# General Service Bulletin

## IFC (CNT07984) Losing Configuration Settings

### Models: S9X2-U and S9X2-D

**ORDER No: FURN-SVB063A-EN**

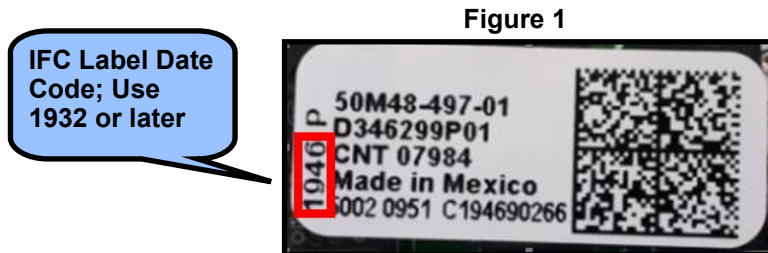
The supplier of the IFC board has determined the root cause to be an error in the configuration bit setting during the software programming phase of these IFC boards. This issue has been corrected in production. The affected boards have been limited to a specific date range that can be identified on the label of the IFC board. The identified date code range is (1918 - 1931). (See page 2 Figure 1) on how to identify the date code on the IFC label.

The recommended corrective action is to replace the IFC board CNT07984 with the date of (1932 or later) in the affected furnaces. (See Figure 1) to identify the date code on the IFC label. This corrective actions includes both uninstalled and installed furnaces.
